MEETING AGENDA

7.	Sanitary: Amendment No. 1 to the Agreement for Technical Services for the Poplar Creek Lining Project.	X
8.	Plan Commission: Recommendation for Final Approval for a new warehouse building for Master Spa Warehouse located at 21675 Doral Rd.	X

**TOWN OF BROOKFIELD
PLANNING COMMISSION RECOMMENDATIONS
MAY 28, 2024**

Strand Associates, Inc.® (Strand) has finished its review of the plan package for the Avery and Birch Development that was received from ACS, Inc. on May 7, 2024, for conformance with the Town specifications and general engineering practices. Before construction may begin, the contractor shall submit all required permits for the development to the state, Wisconsin Department of Natural Resources, Town, and any other relevant agencies. New drawings and a letter describing the revisions should be returned to Strand after the following concerns have been addressed.

SITE PLAN

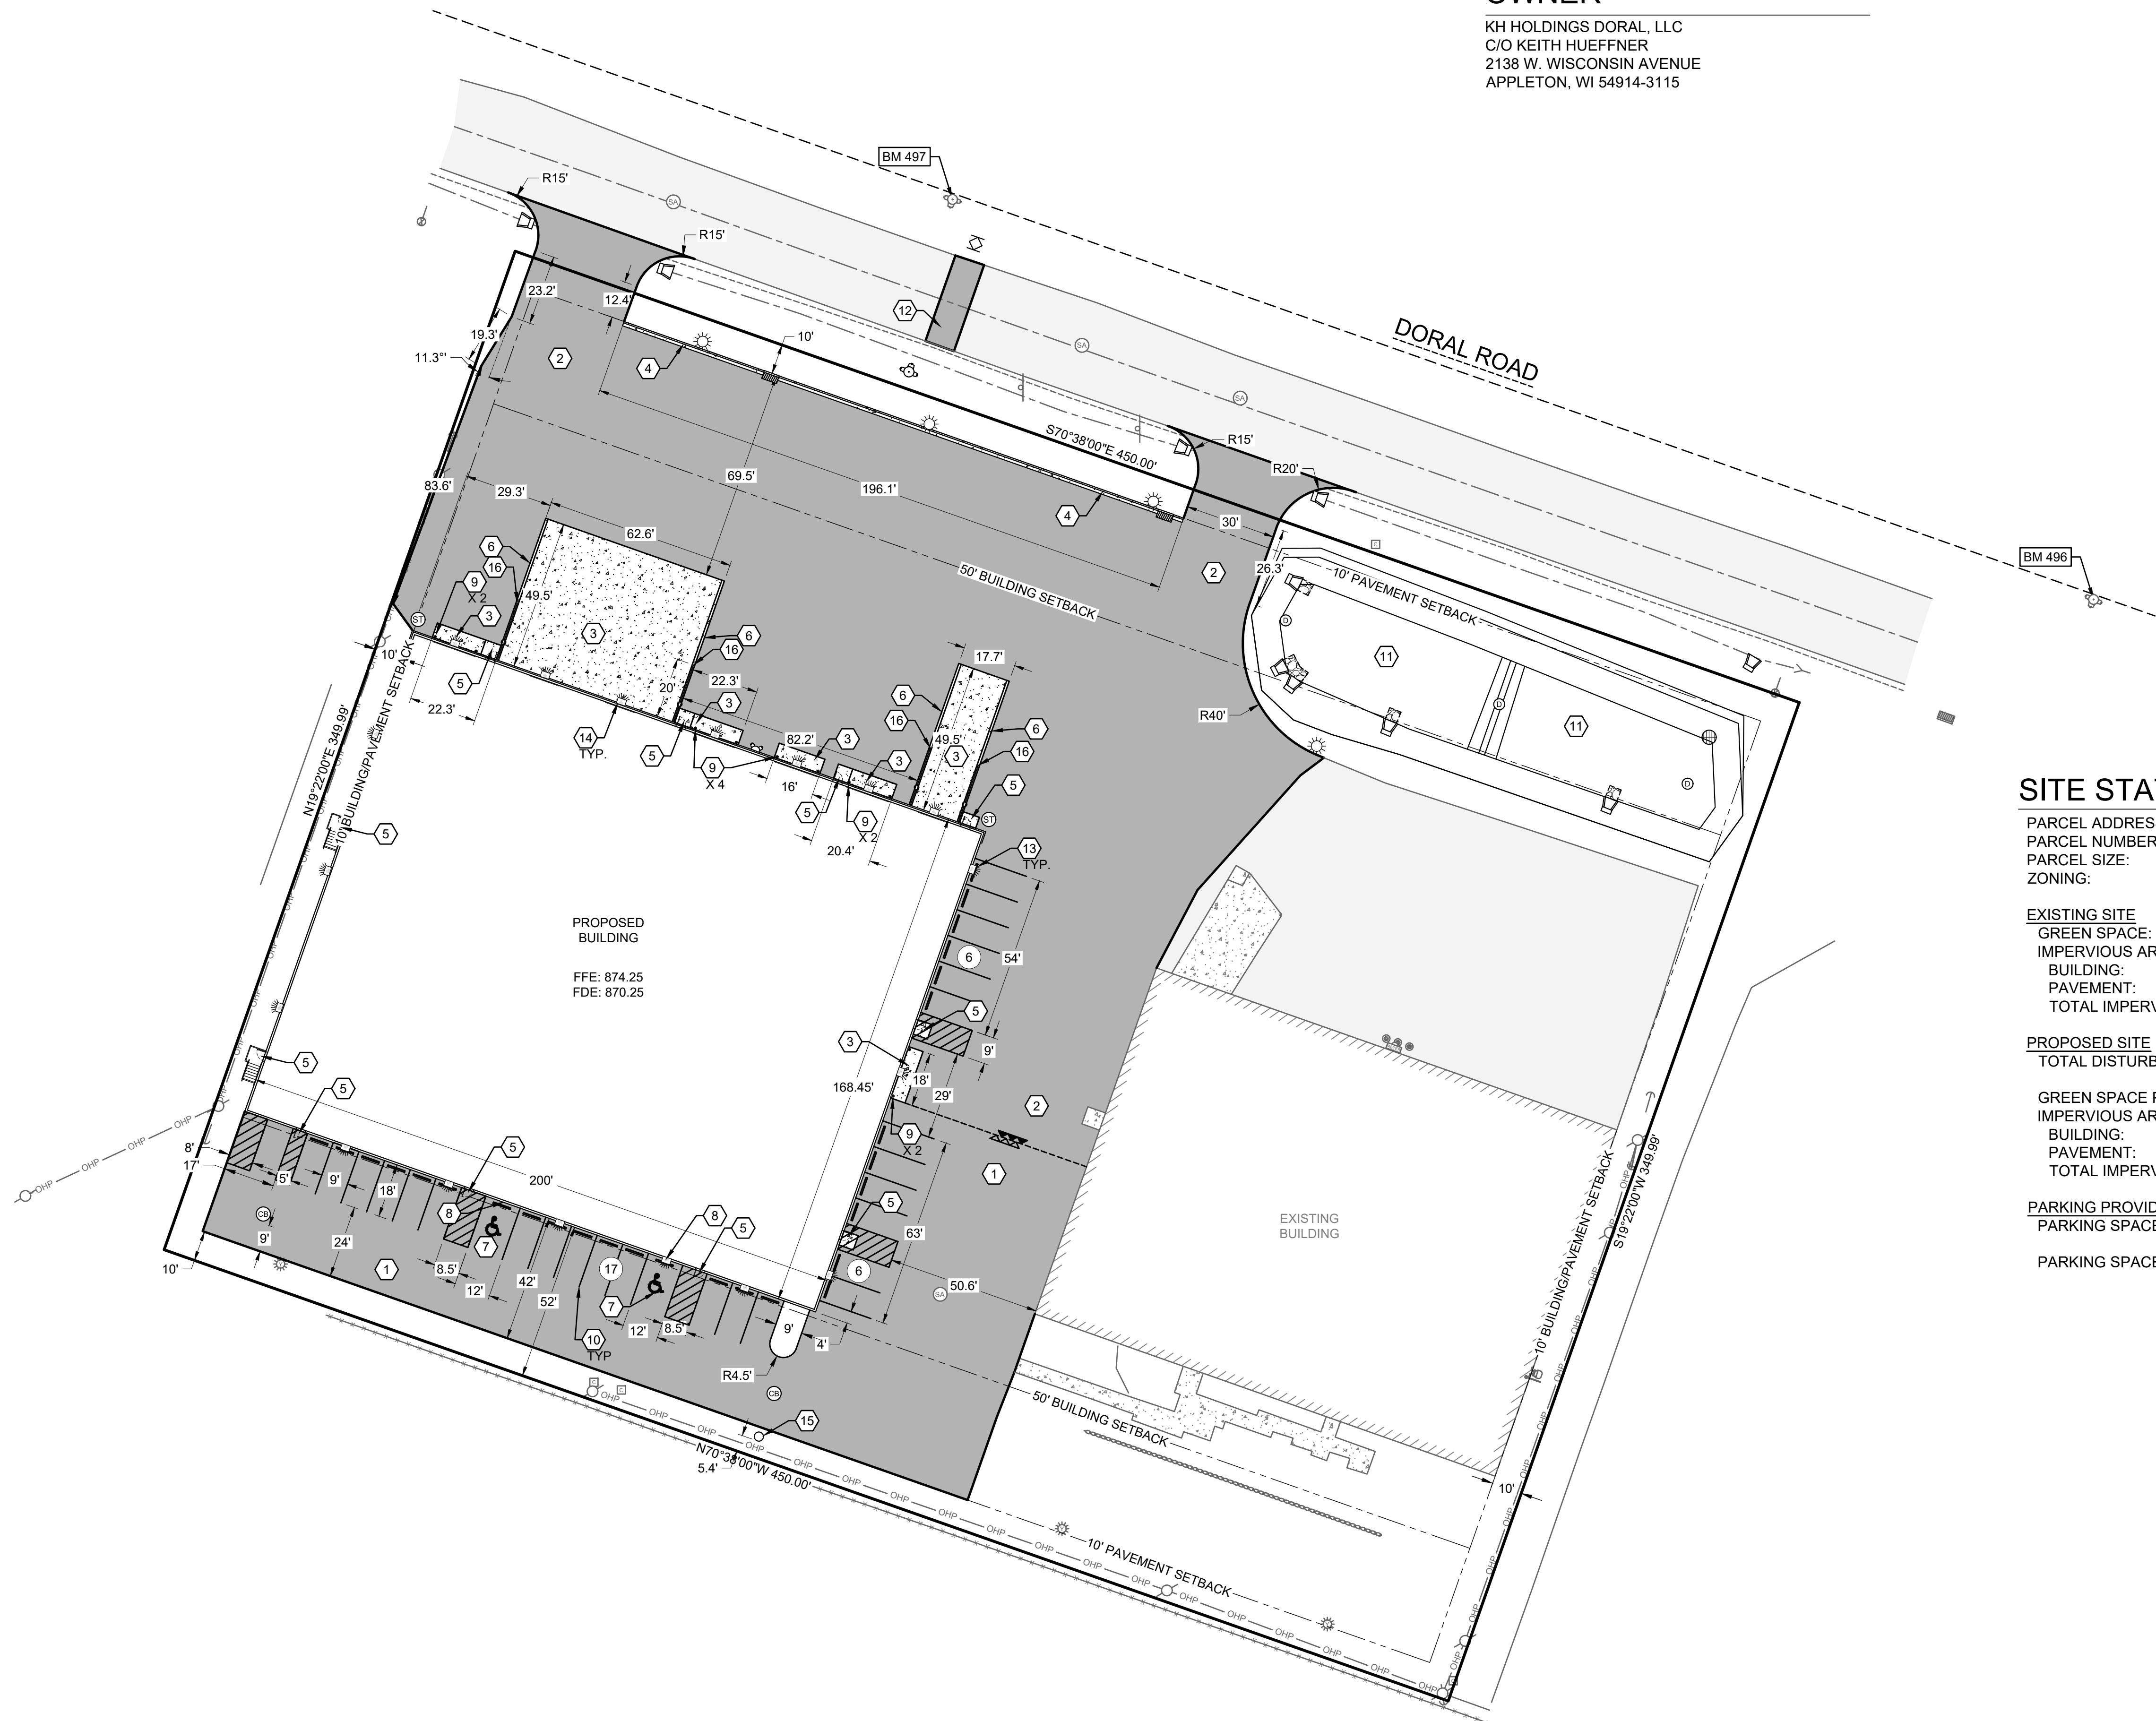
Site Plan–Sheet C 2.0

- b. *Strand's Current Comment–The key notes and symbols are acknowledged. Strand has no further comment.*
2. Based on the architectural drawings, it appears there will be a railing on the loading dock retaining walls. It is recommended to add a detail for the railing showing the type with dimensions and installation notes and details.

3. A turning-moving exhibit should be provided to verify the largest vehicle (including any emergency vehicles) that will access the site can perform the required turning movements with the proposed layout.

- a. **Mach IV Response–The proposed ADA stalls are dimensioned as 12'X18'.**

- a. **Mach IV Response–The limits of heavy- and standard-duty asphalt are indicated by keyed notes and symbol markings on sheet C2.0. Please refer to keyed note list on sheet C2.0, and symol legend on Sheet C0.1.**

- a. **Mach IV Response–Railing has been added to the site plan.**
 - b. *Strand's Current Comment–It appears that the railing was added to the site plan. It is recommended to add a railing detail. Strand has no further comment or no response is needed.*

- a. **Mach IV Response–A vehicle turning exhibit for a WB-40 semi-trailer has been included with the final plan commission submittal package.**
 - b. *Strand's Current Comment–Turning template was reviewed and there is no further comment.*

- b. *Strand's Current Comment—Strand has no further comment.*
- 5. It should be verified that the proposed ADA route into the building is ADA compliant.
 - a. **Mach IV Response—Spot grades in the ADA stalls are shown on sheet C4.0.**
 - b. *Strand's Current Comment—The grades were reviewed and the route appears to be ADA compliant. Not further comment.*

UTILITY PLAN

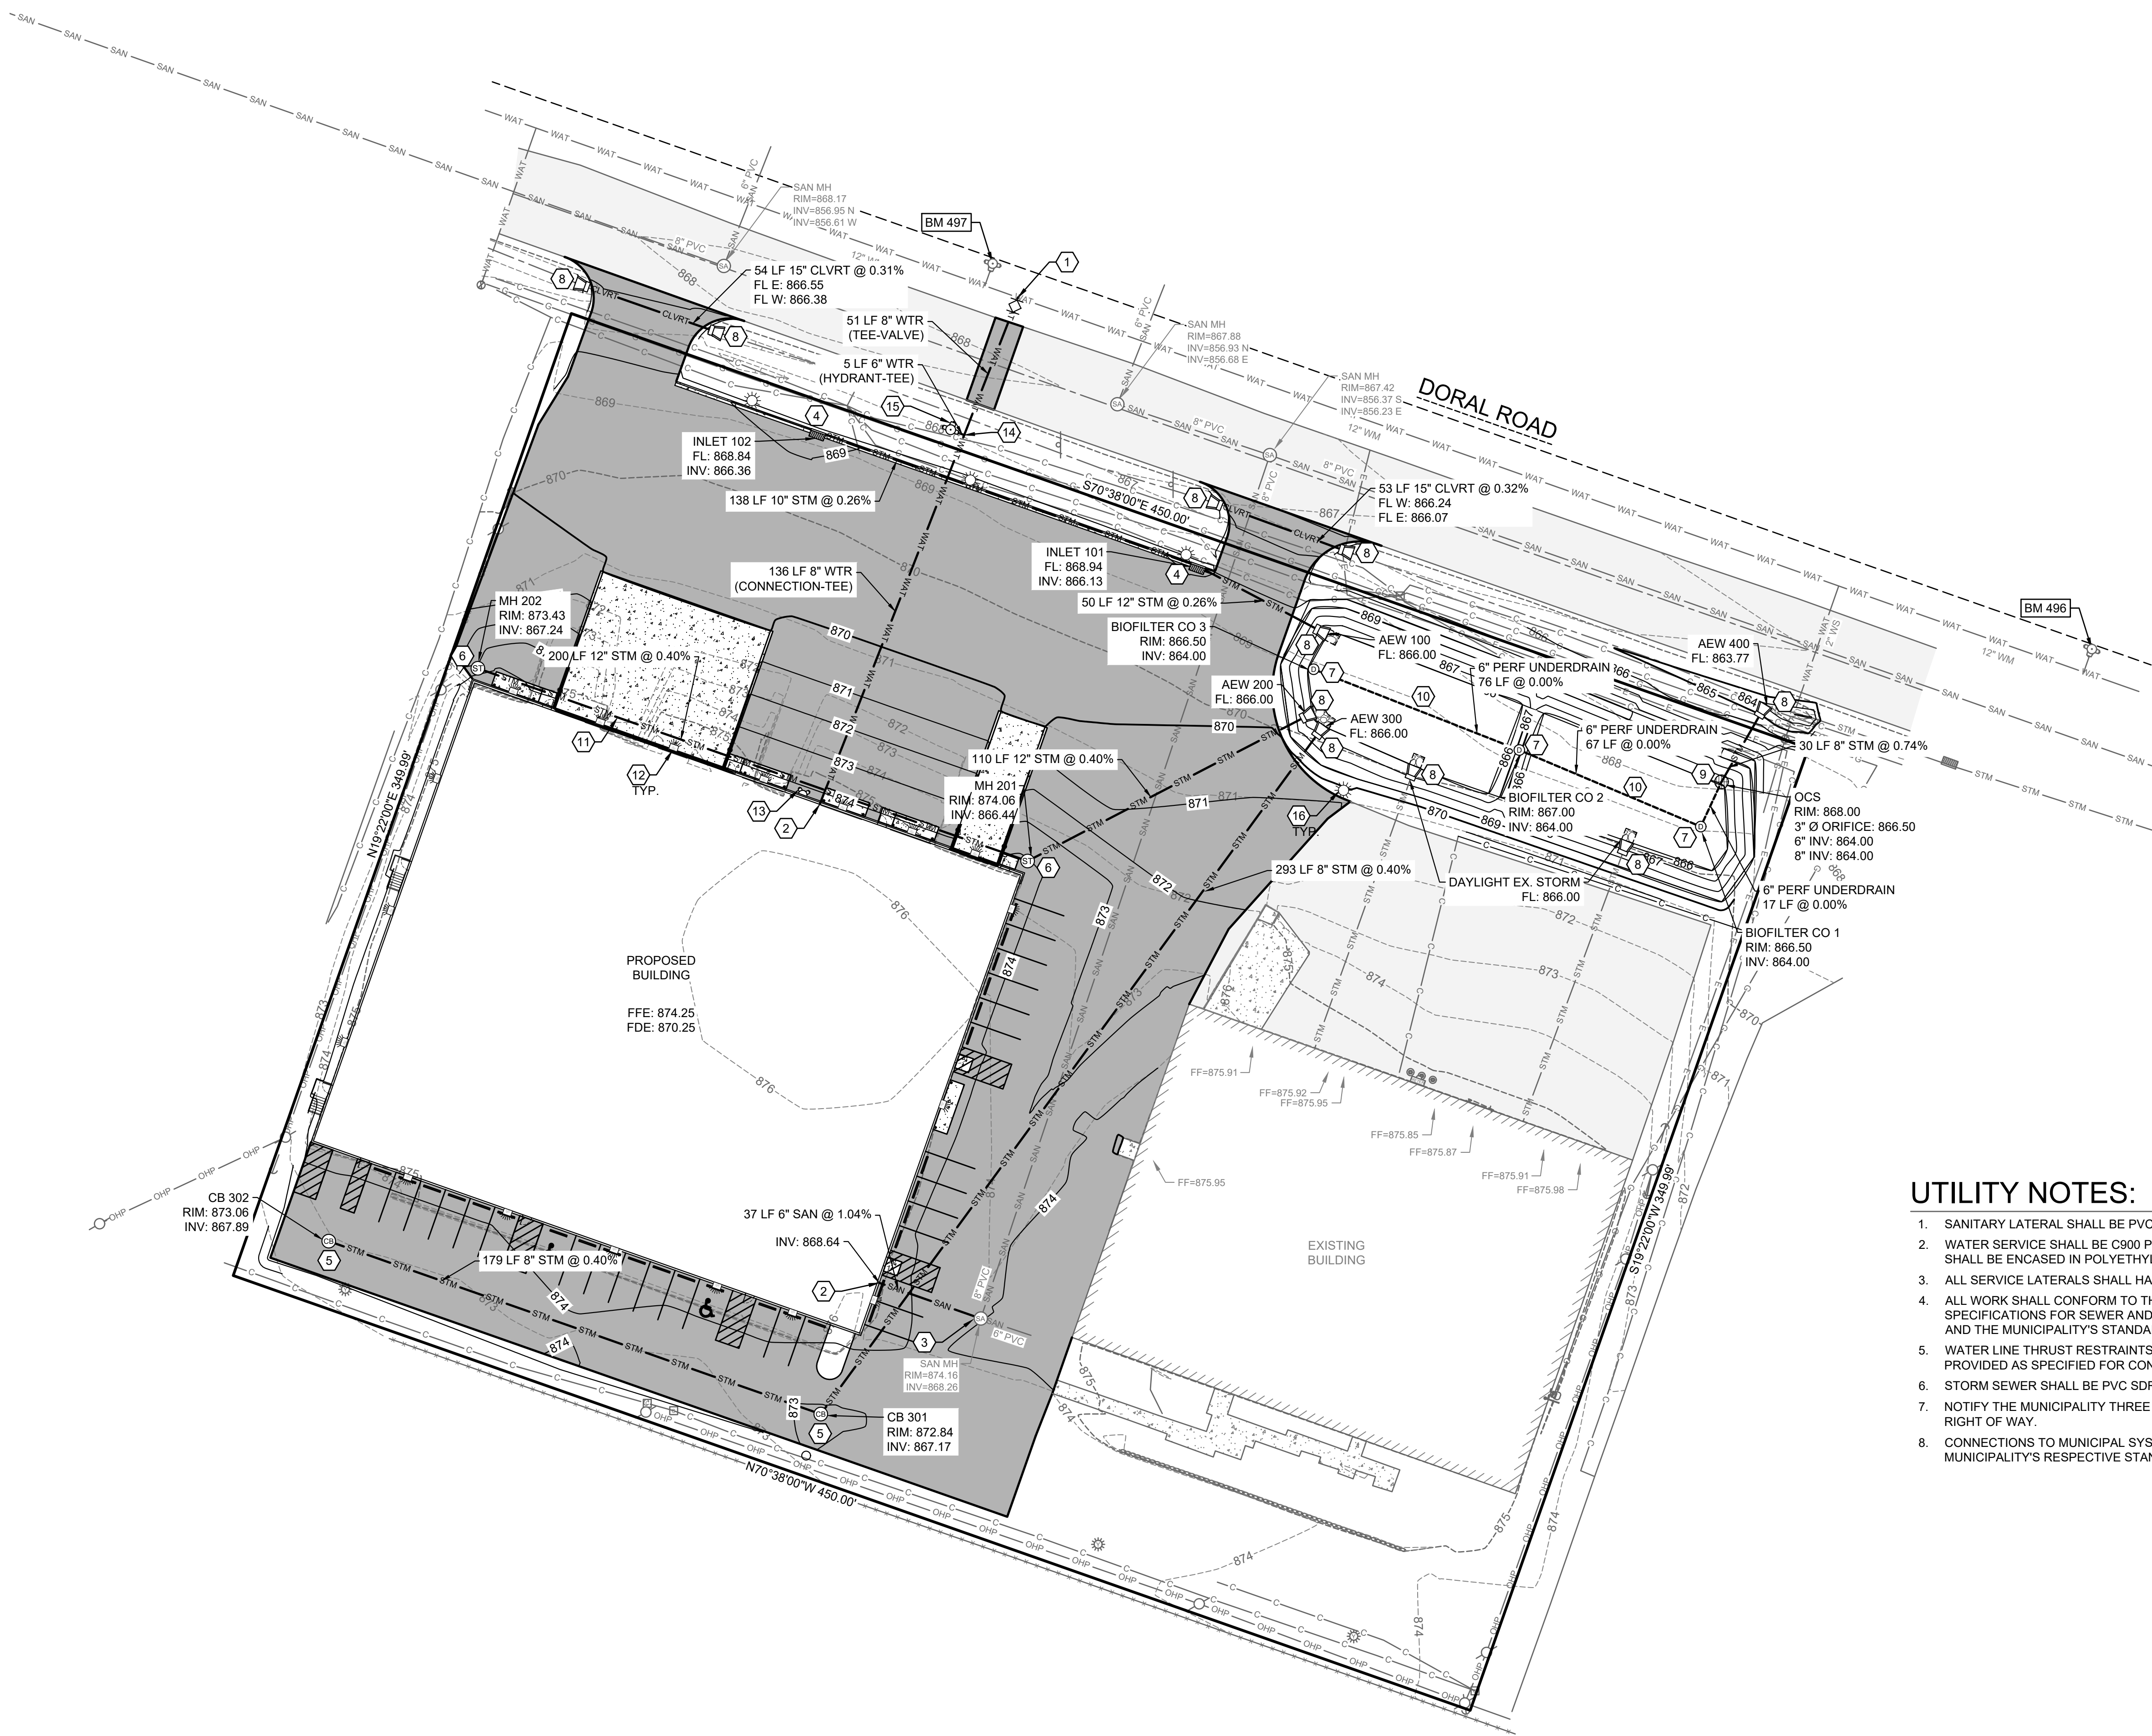
Utility Plan—Sheet C 3.0

- a. **Mach IV Response—Comment acknowledged.**
 - b. *Strand's Current Comment—Strand has no further comment.*
- 2. The water calculations and modification to the existing water service form were reviewed. The application is for an 8-inch service and the drawings show an 8-inch service; however, the calculations show only a 6-inch service is needed. With that being said, the demand of 18.8 gallons per minute (gpm) is small compared to a 6- or 8-inch service and either will meet the requirement. The service includes capacity for the fire protection system. The calculations sheet indicates no water meter, but there will need to be a water meter for the domestic supply. Based on 18.8 gpm and unknown anticipated headloss, it is recommended that a 3/4-inch ultrasonic meter for domestic is used.

- a. **Mach IV Response—An updated copy of the Town's water service modification application/calculation is attached.**
 - b. *Strand's Current Comment—The application/calculations were reviewed. Strand has no further comment.*

- a. **Mach IV Response—Comment acknowledged. A fire hydrant has been added in the ROW which is within 150' of the proposed fire department connection on the building.**

- b. *Strand's Current Comment—It appears that the proposed hydrant is in the right-of-way and 150 feet from the building. Strand has no further comment.*
